ADDENDUM NO. 1

TO: PLANS AND SPECIFICATIONS FOR STATE OF MISSOURI

**Renovate Lobby and Restrooms 1st and 2nd Floor
Howerton State office Building
Jefferson City, Missouri
PROJECT NO.: O2339-01**

A-207

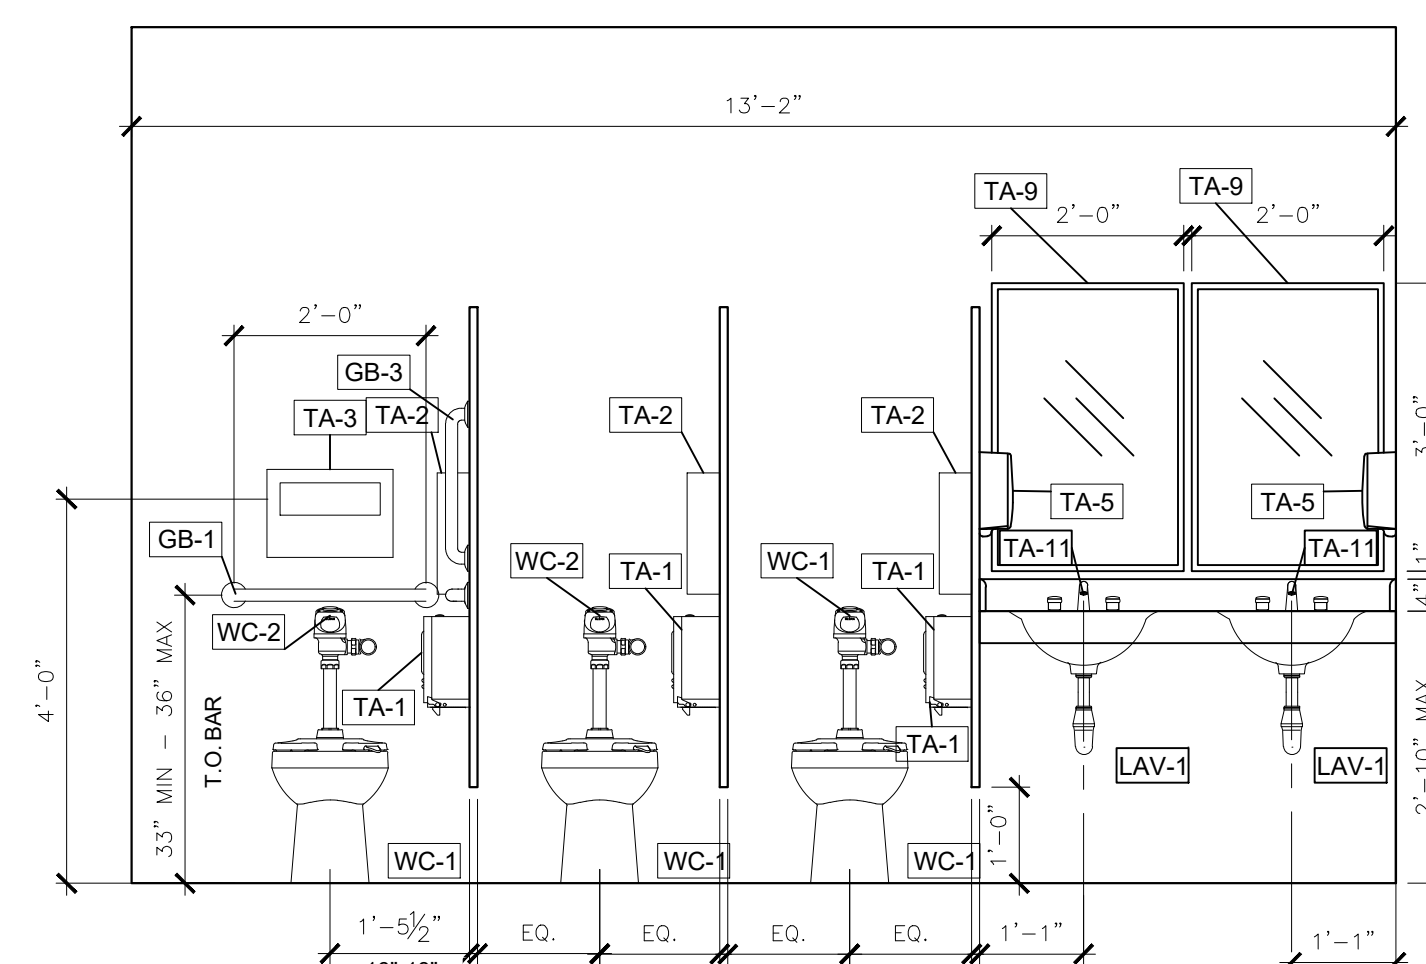
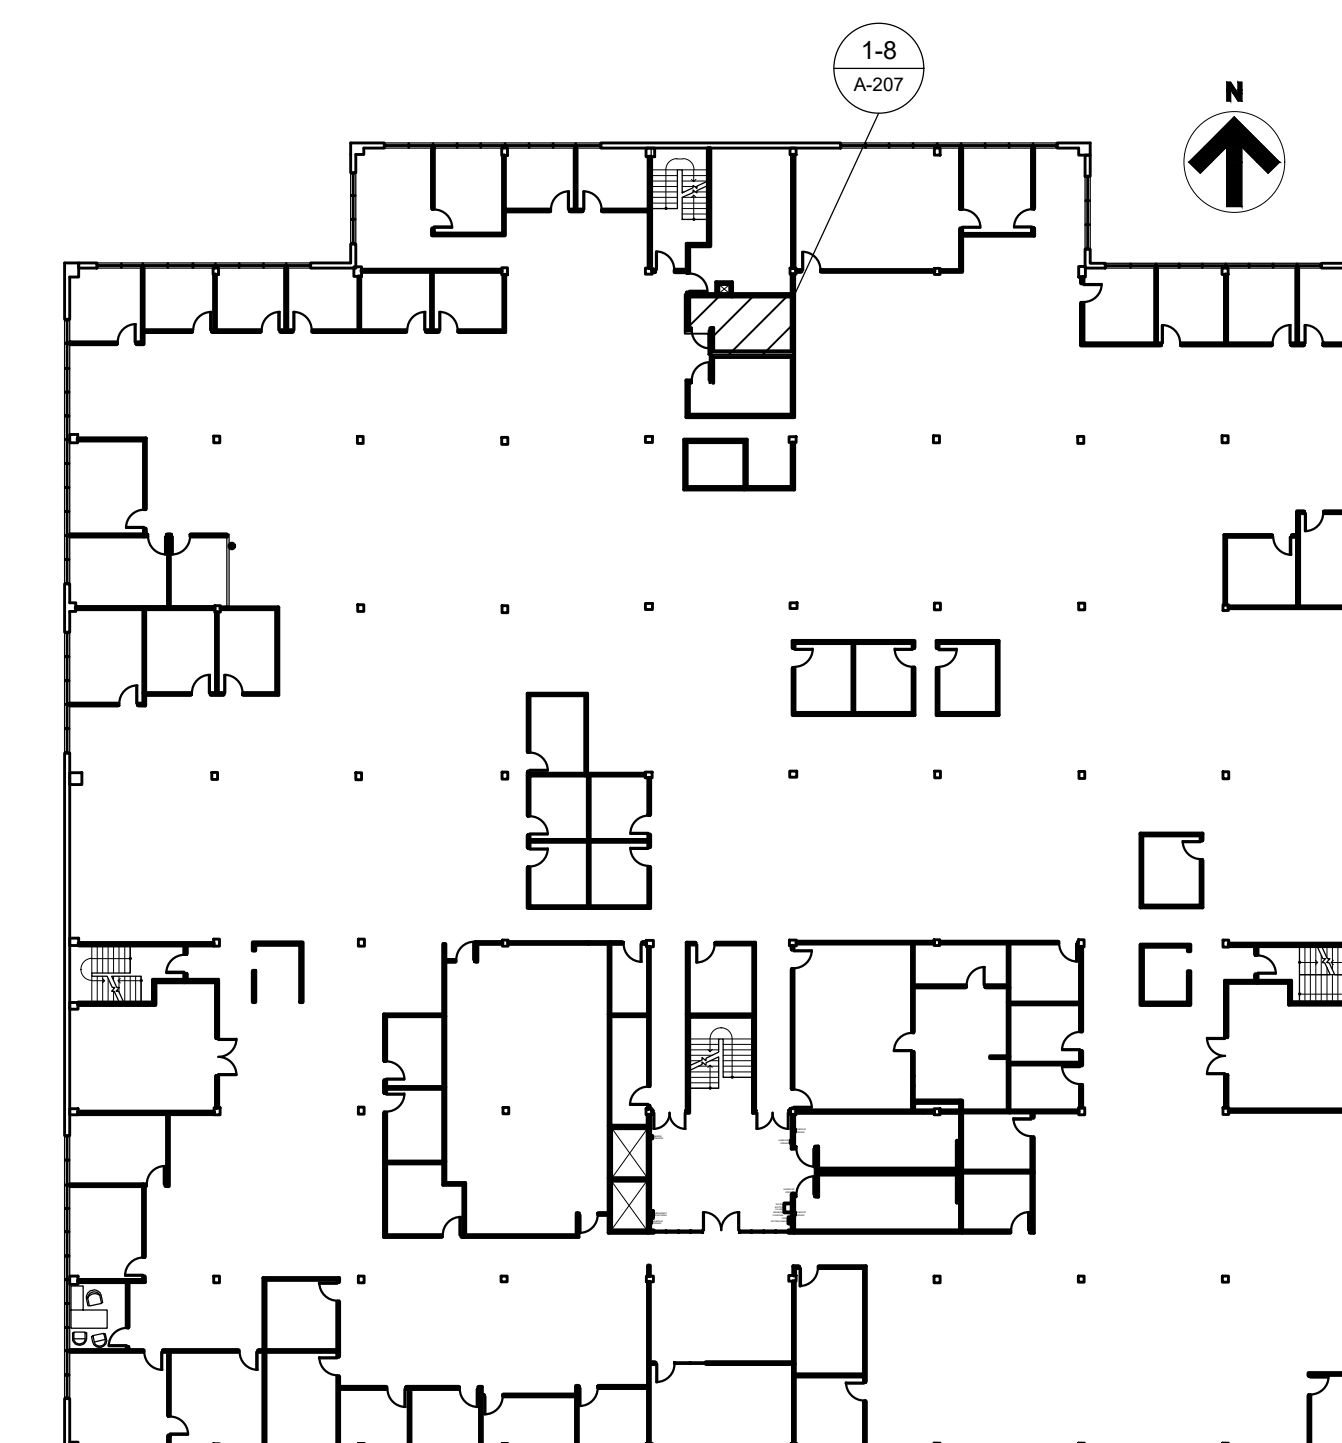
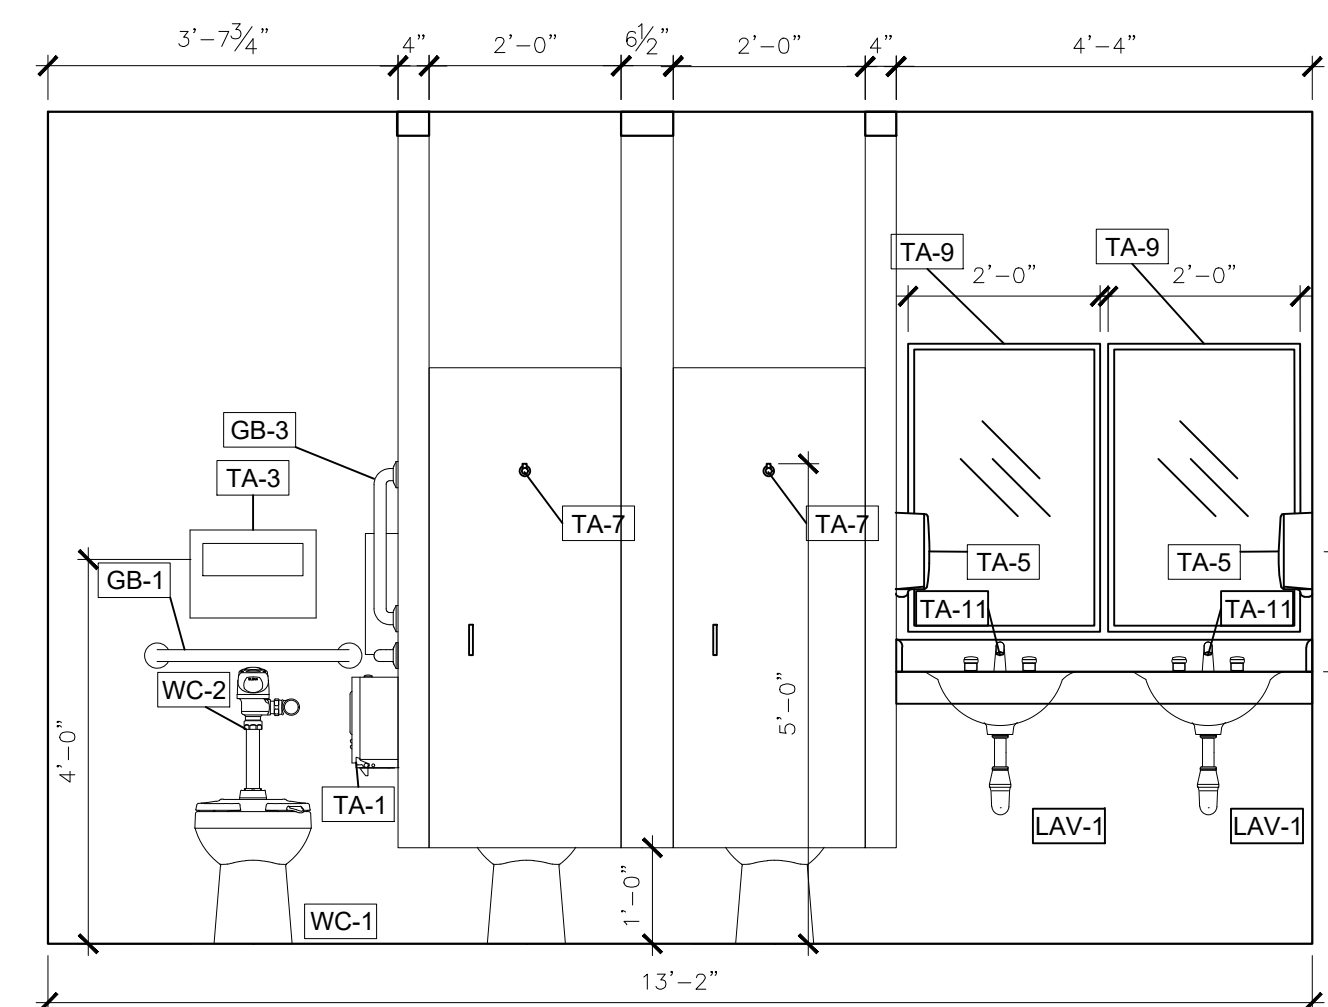
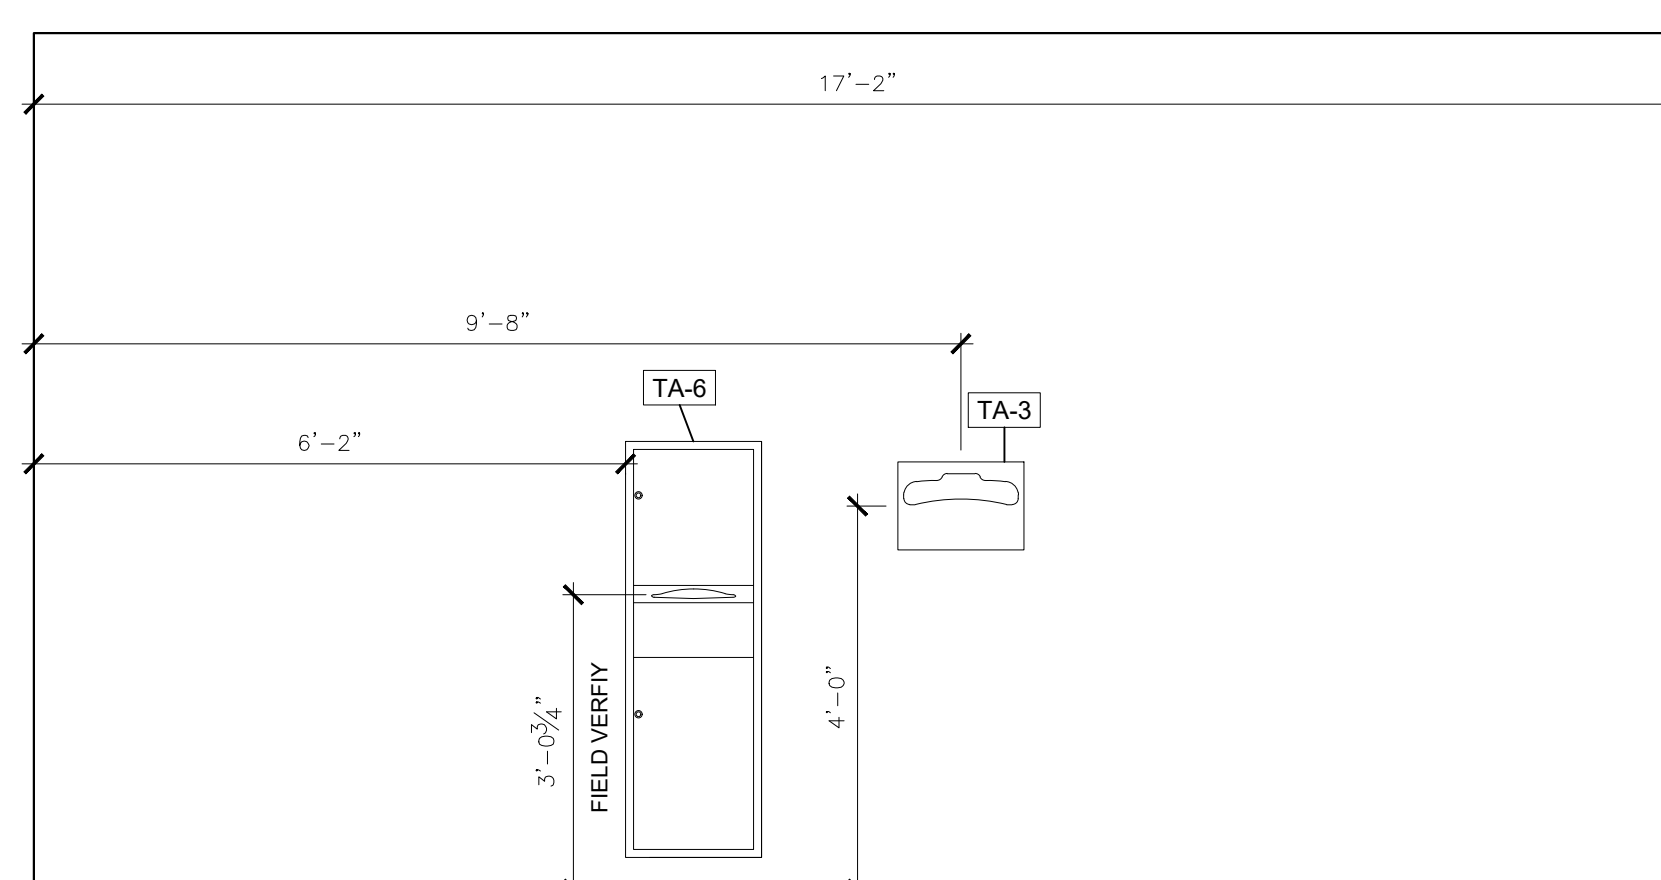
A-207

1. Restroom Finish Schedule: Clarifications per mark.
 - GB-1 Changed grab bar to 36" grab bar.
 - GB-2 Changed grab bar to 42" grab bar.
 - GB-3 Changed grab bar to 18" grab bar.
 - TA-7 Changed coat hook to coat hooks (to be installed inside of stalls)
 - TA-8 Changed mirror to 24" x 72" mirror.
 - TA-9 Changed mirror to 24" x 36" mirror.
2. Changed note from: See A-601 for full fixture schedule to See sheets A-104 - A-105 for full fixture schedules.

SHEET TITLE:
SECOND FL. MEN'S
STAFF RESTROOM
ELEVATIONS

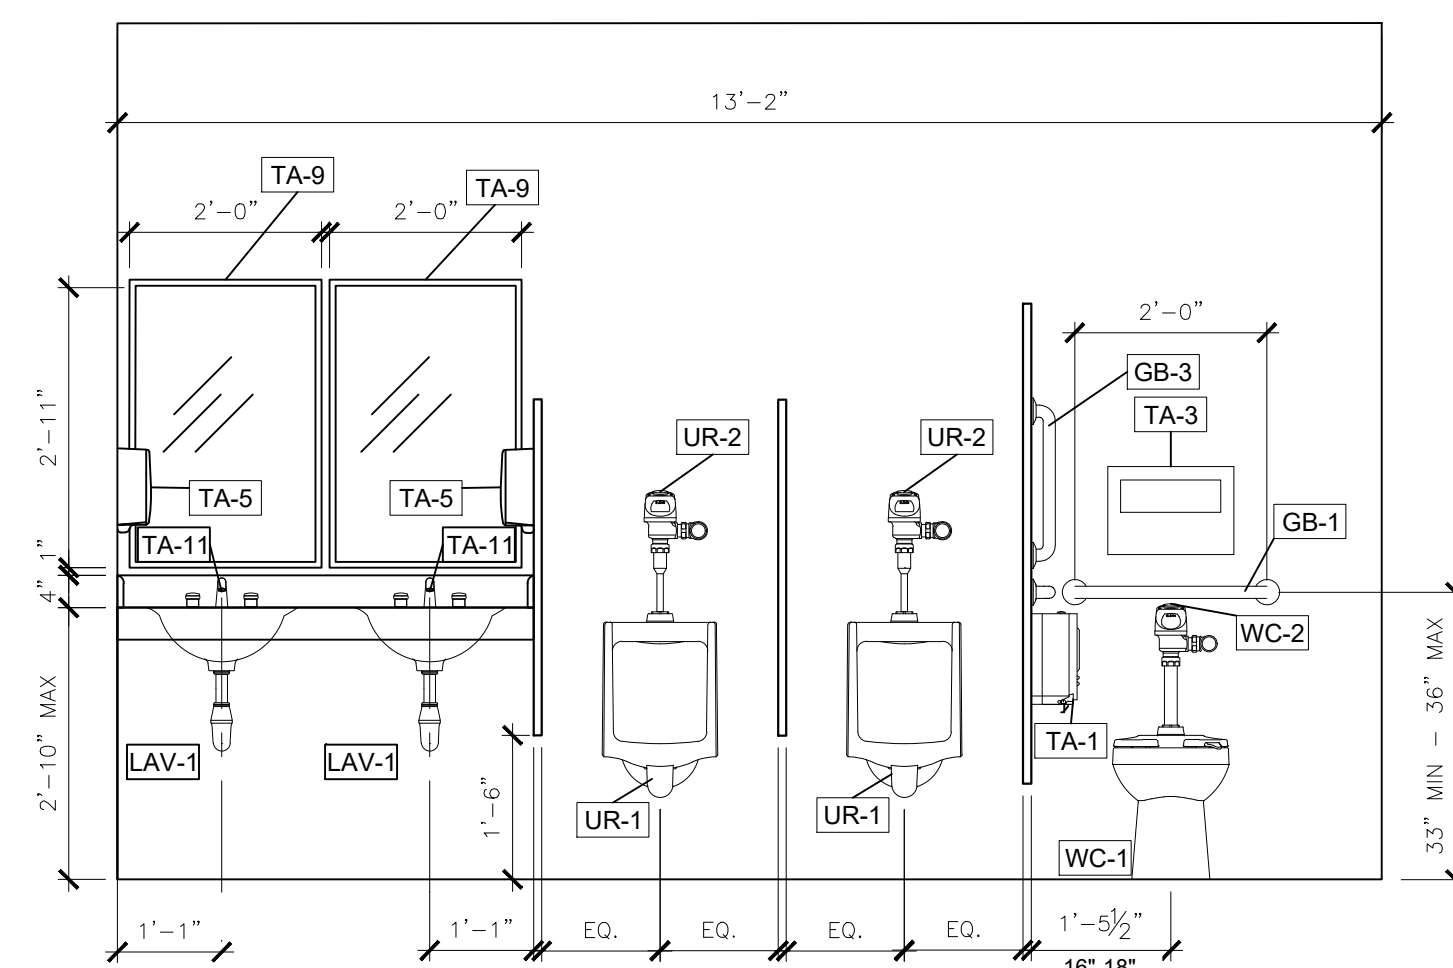
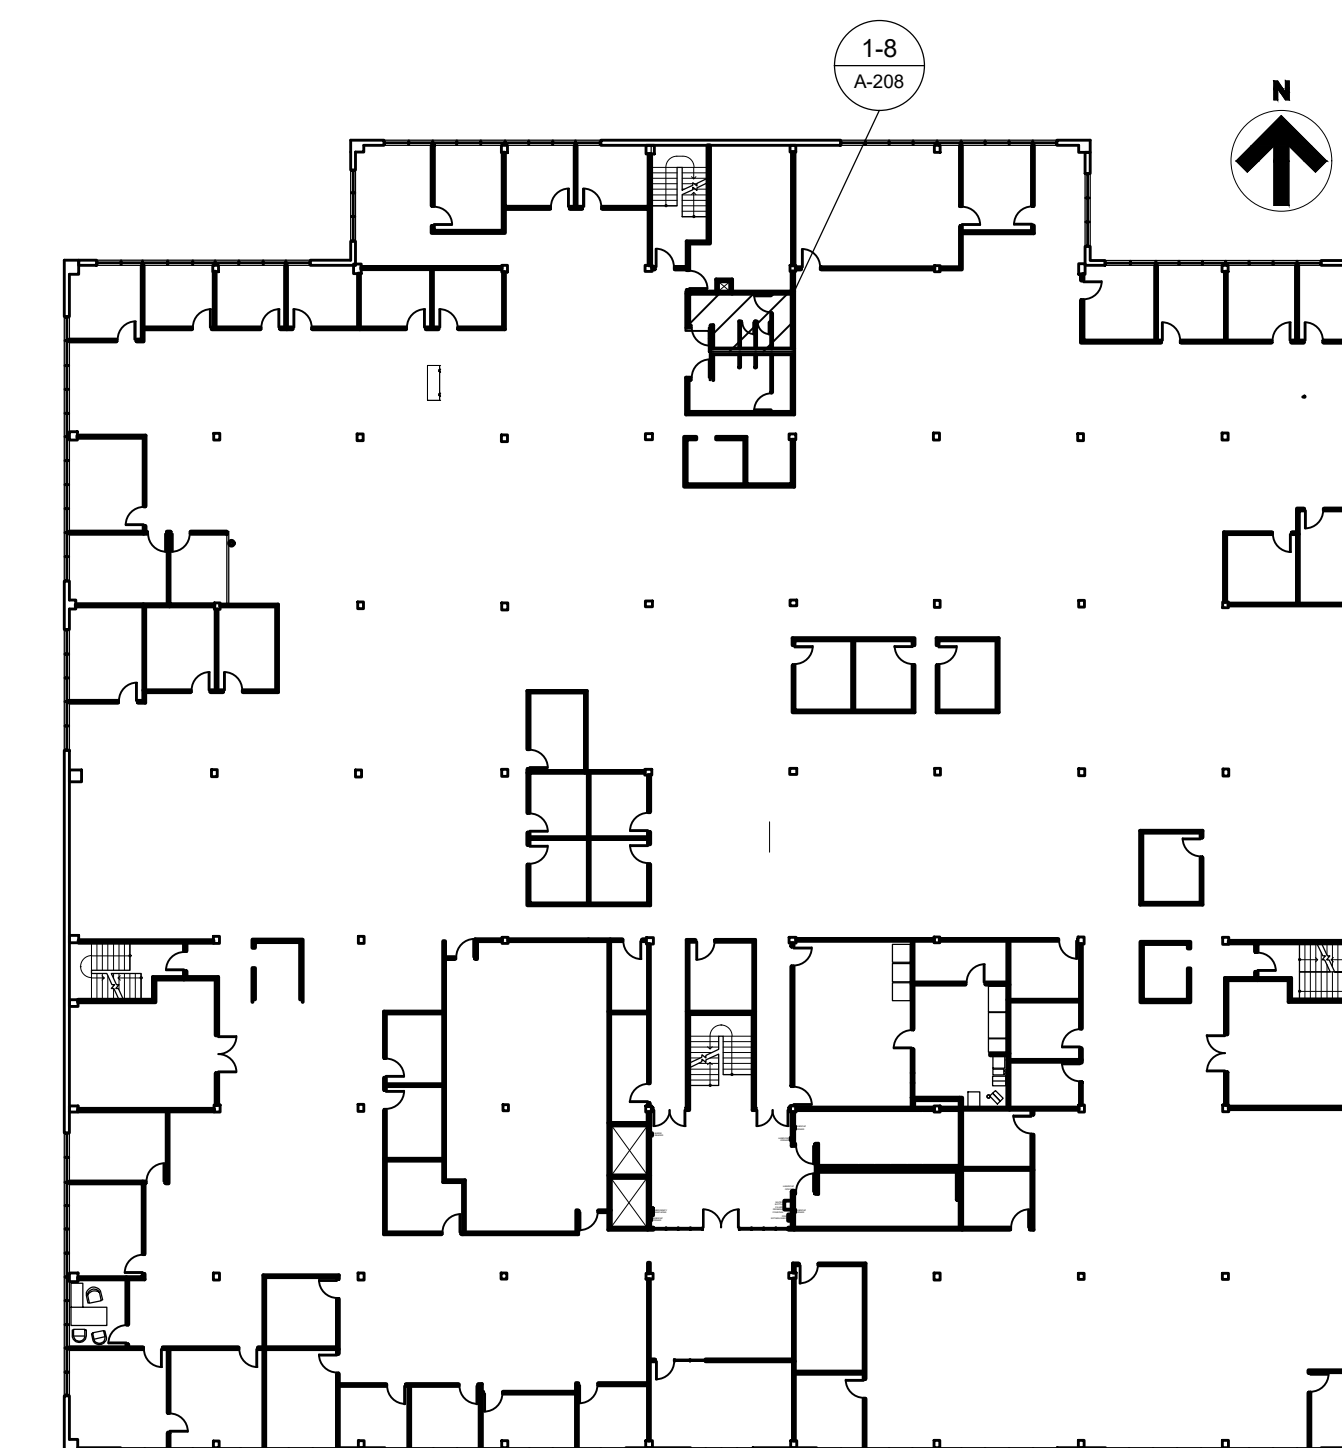
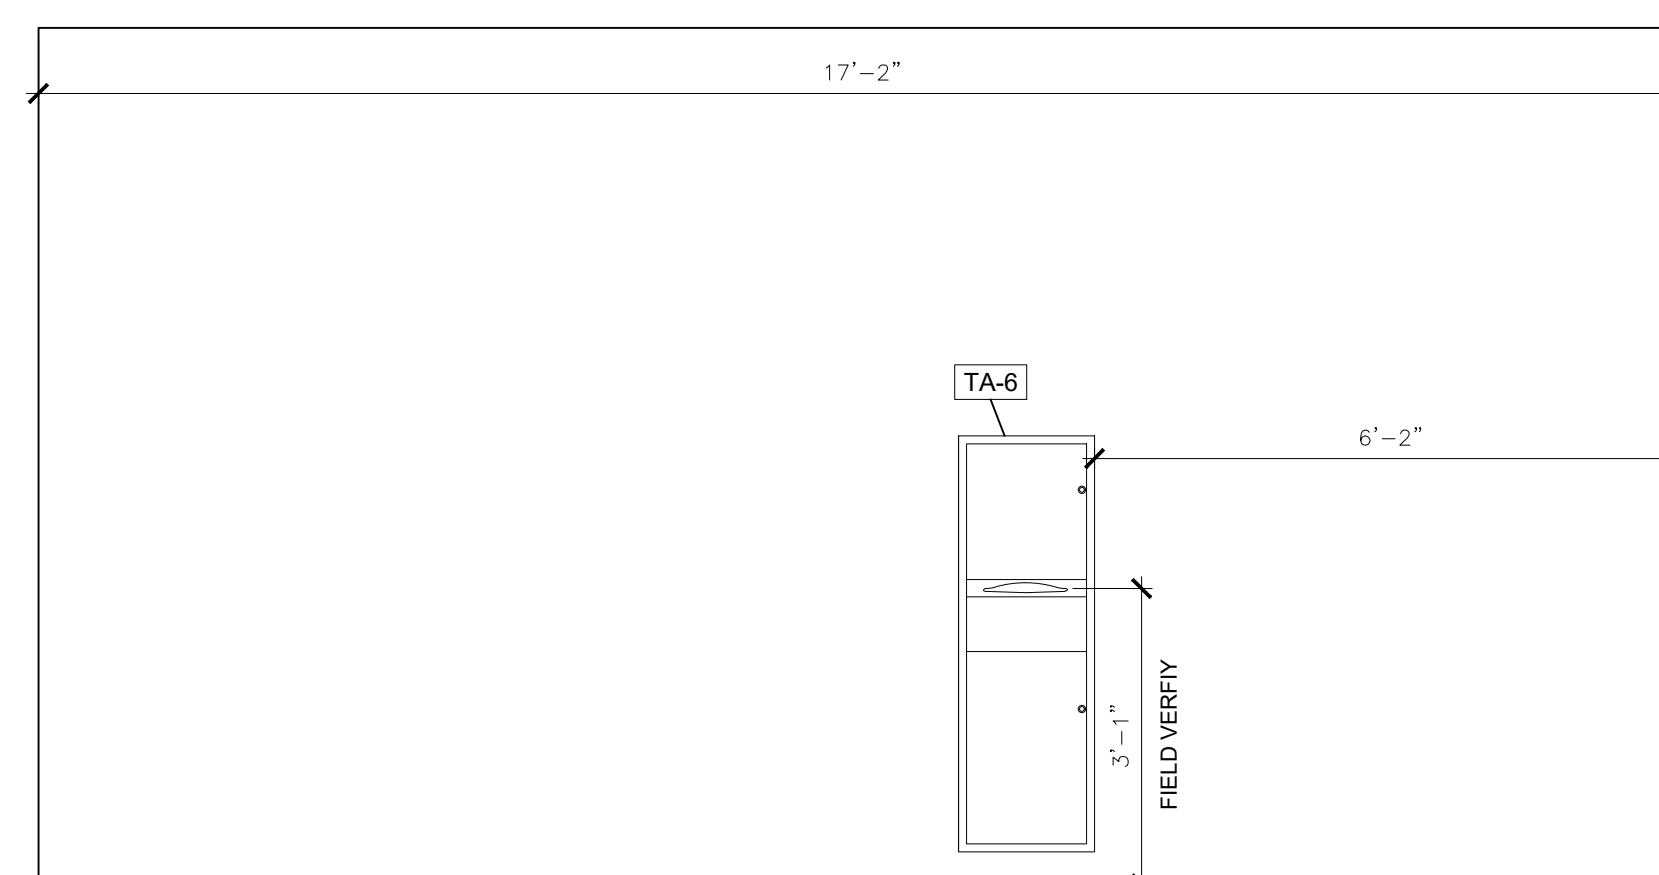
A-208

1. Restroom Finish Schedule: Clarifications per mark.
 - GB-1 Changed grab bar to 36" grab bar.
 - GB-2 Changed grab bar to 42" grab bar.
 - GB-3 Changed grab bar to 18" grab bar.
 - TA-7 Changed coat hook to coat hooks (to be installed inside of stalls)
 - TA-8 Changed mirror to 24" x 72" mirror.
 - TA-9 Changed mirror to 24" x 36" mirror.
2. Changed note from: See A-601 for full fixture schedule to See sheets A-104 - A-105 for full fixture schedules.
